## Department of Transportation

#### MEMORANDUM

**SUBJECT:** ZC Case No. 06-11Q/06-12Q/01-17E/06-11R – 2025 F Street NW (George Washington University Thurston Hall)

Figure 1 – Site Design and Access (Source: Gorove Slade October 18, 2019 CTR, Figure 6)

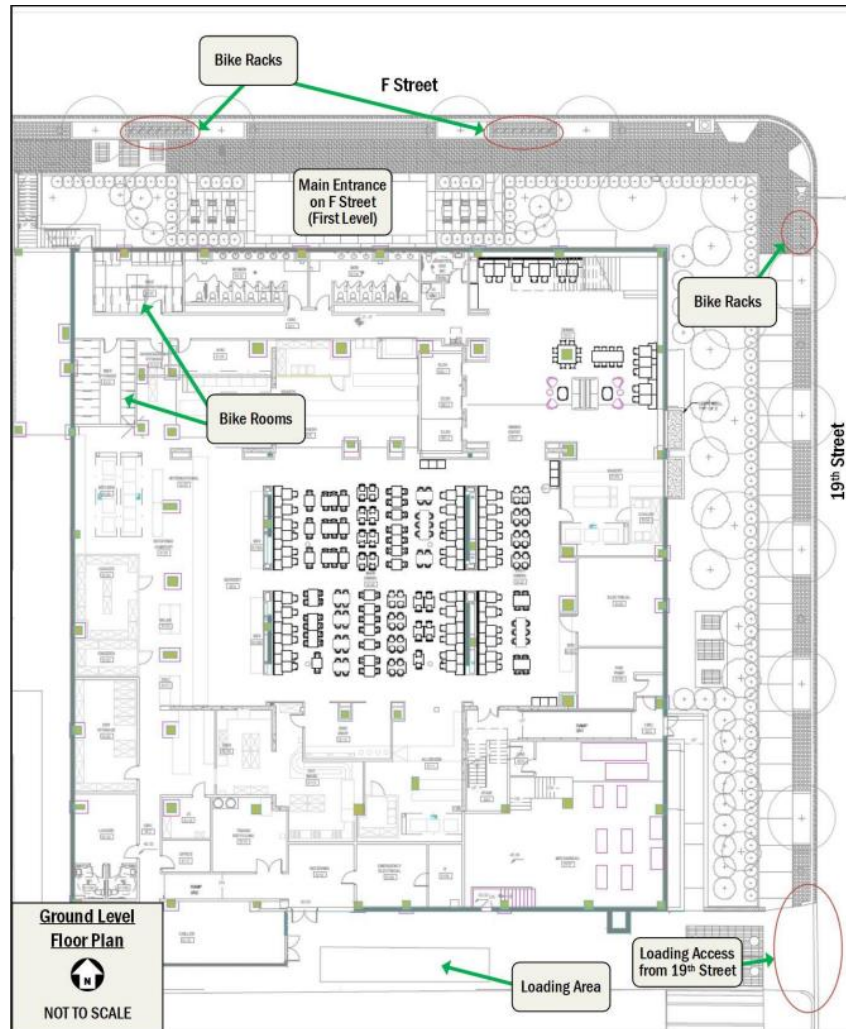
The site is bounded by F Street to the north, 19<sup>th</sup> Street to the east, George Washington University Alumni House to the west, and mixed-use to the south. Access to the main pedestrian entrance is on F Street NW and the project is proposing two new emergency egress areaways: one on F and 19<sup>th</sup> Streets NW. There is no on-site vehicle parking and loading is proposed to occur where it currently does from a curb cut on 19<sup>th</sup> Street NW. Long-term bicycle parking is located in a bicycle room on the ground floor. A site plan is shown in Figure 1.

- The below grade dining space requires two (2) points of emergency egress: one on F Street NW and the other on 19<sup>th</sup> Street NW. These areaways project beyond 6.5 feet and do not comply with public space regulations. The Applicant should reduce the areaways as much as possible, but will likely need to apply for a code modification with DCRA.
- The new light wells on 19<sup>th</sup> Street NW appear to meet the areaway projection requirements.
- There is an existing berm around the site that should not be regarded with the exception of the new seating area on F Street NW. Any retaining walls in the sitting area should not be taller than the existing grade they are retaining.
- Any special paving at the entrance will require a Covenant of Maintenance.

- The sidewalk materials should show brick on F Street NW and concrete on 19<sup>th</sup> Street NW.
- The bike racks will need to be positioned in such a way to ensure the wheels do not project into the pedestrian clear path.
- Existing parking meters may be required to be upgraded to multi-space meters at the Applicant’s expense.
